Safety Recall Trucks

Date	Group.	No.	Page
07.14	SC0379		1(12)

Electronic Flasher
CHU, CT, CV, CXU, GU, LEU, MRU,
TD

SAFETY RECALL INFORMATION:

- 1 x 22136513 – Flasher

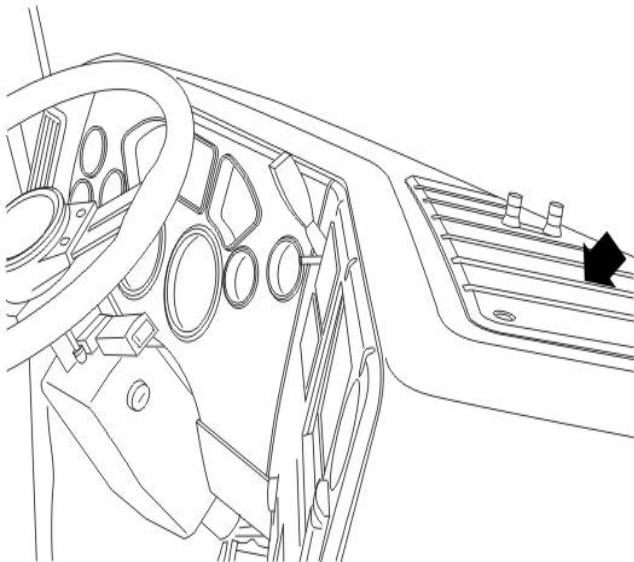
To address these concerns, replace the flasher with a new style flasher.

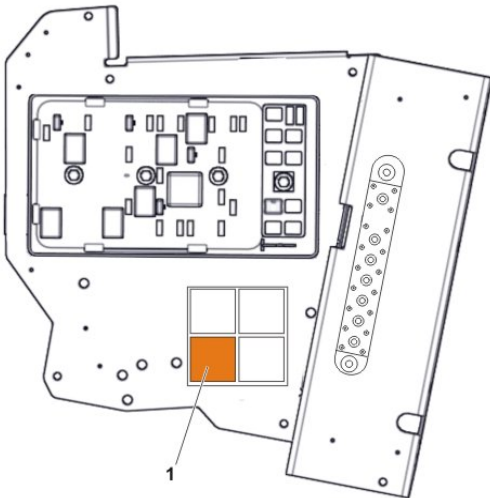
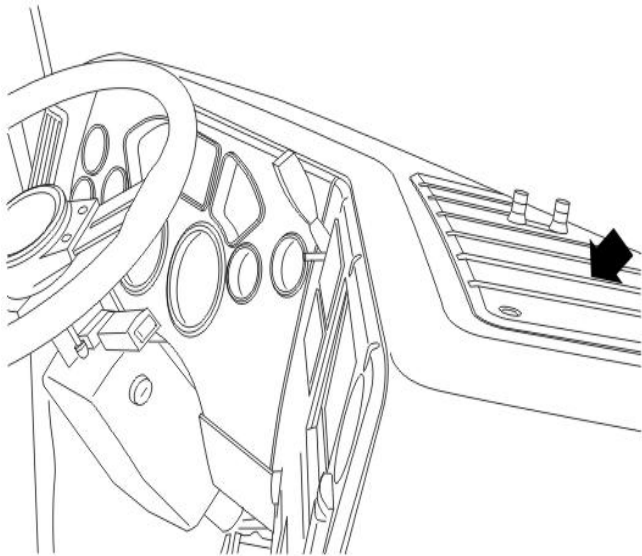
5. Locate, remove and discard the flasher (part number 20971013).

6. Install the new flasher (part number 22136513).

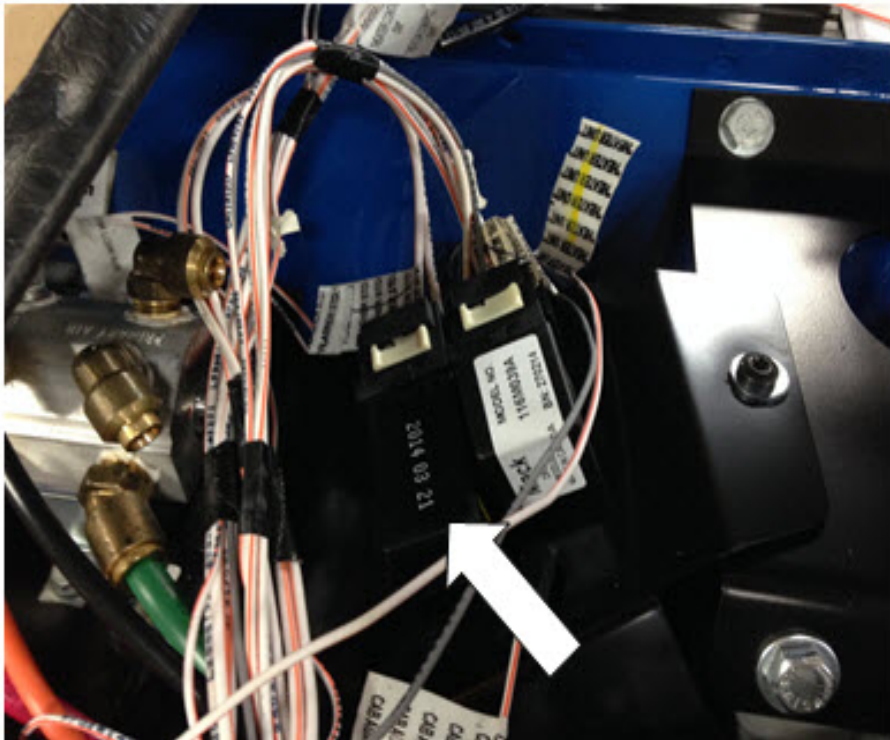
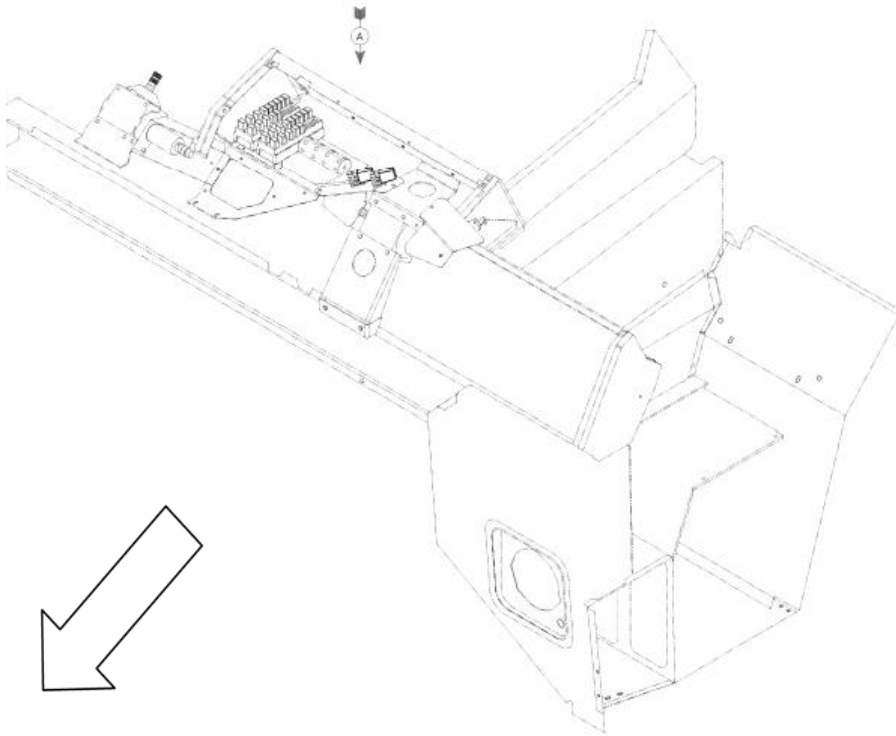
4. Locate, remove and discard the flasher (part number 20971013).

5. Install the new flasher (part number 22136513).

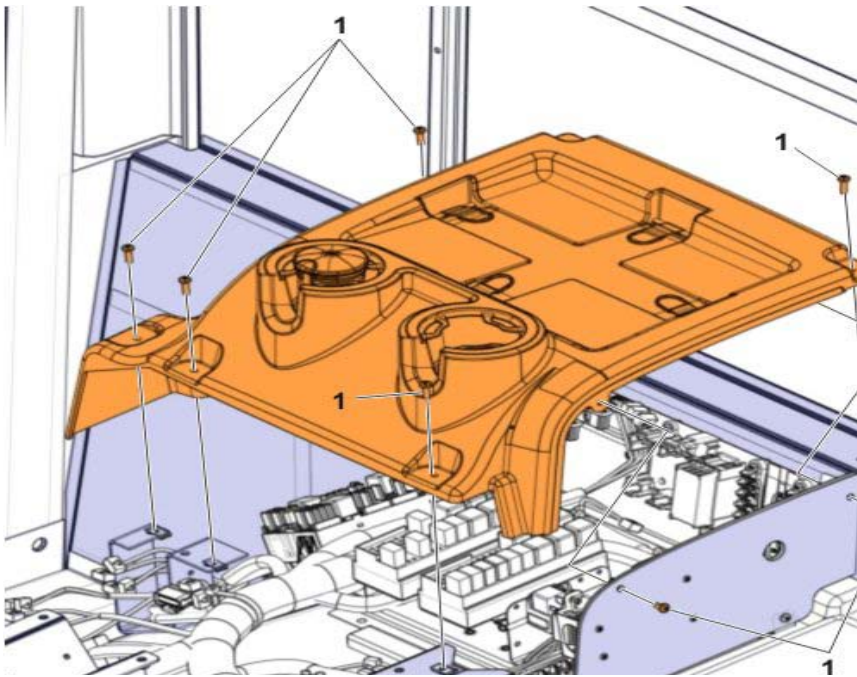
4. Locate, remove and discard the flasher (1) [part number 20971013].

5. Install the new flasher (part number 22136513).
6. Install the center dash panel for the flasher and relay center.

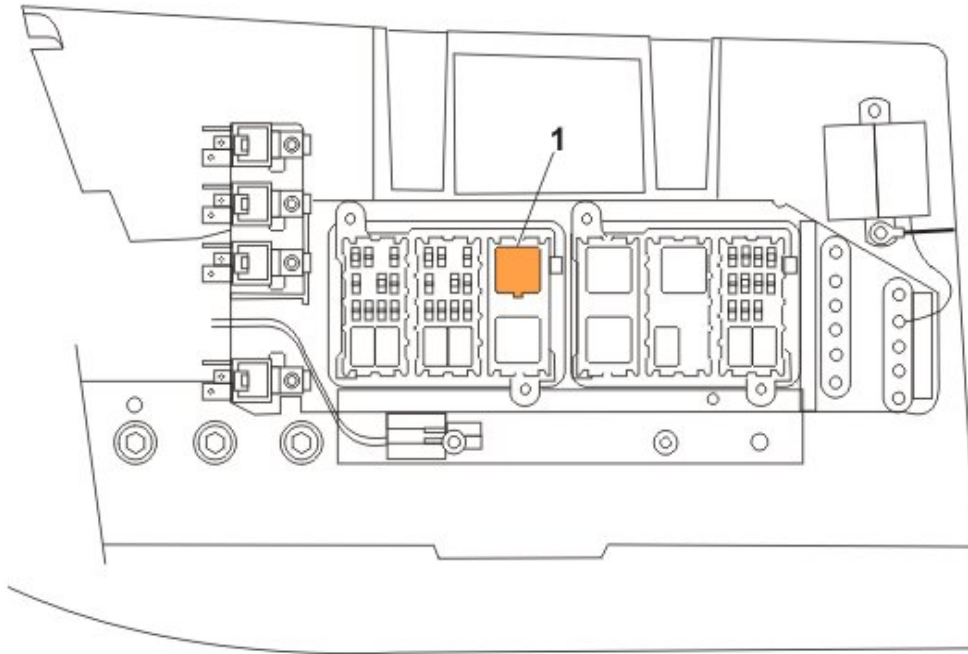
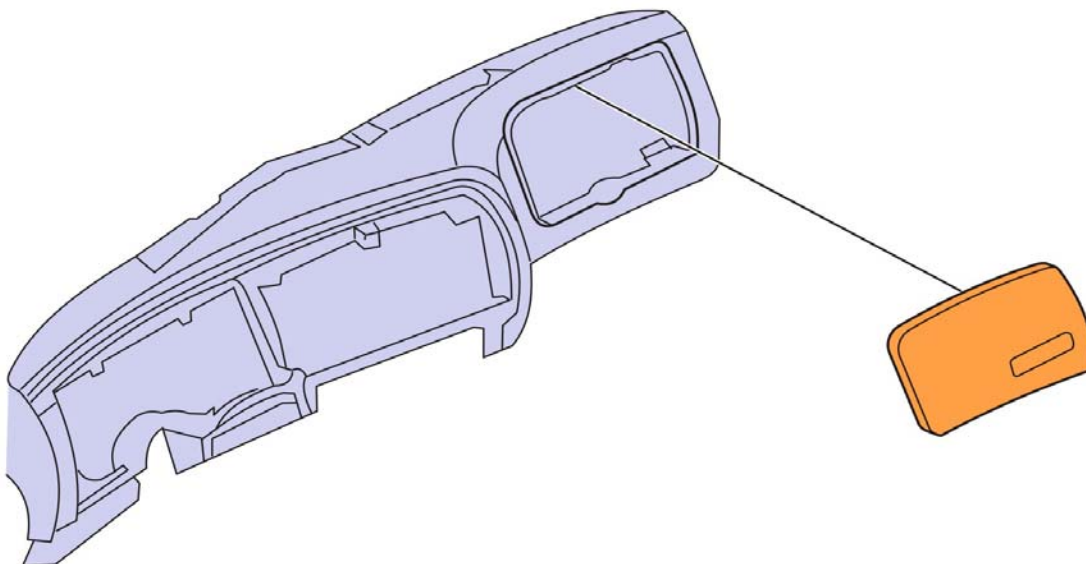
4. Locate, remove and discard the flasher (1) [part number 20971013].

5. Install the new flasher (part number 22136513).
6. Install the glove box lid or dash panel.
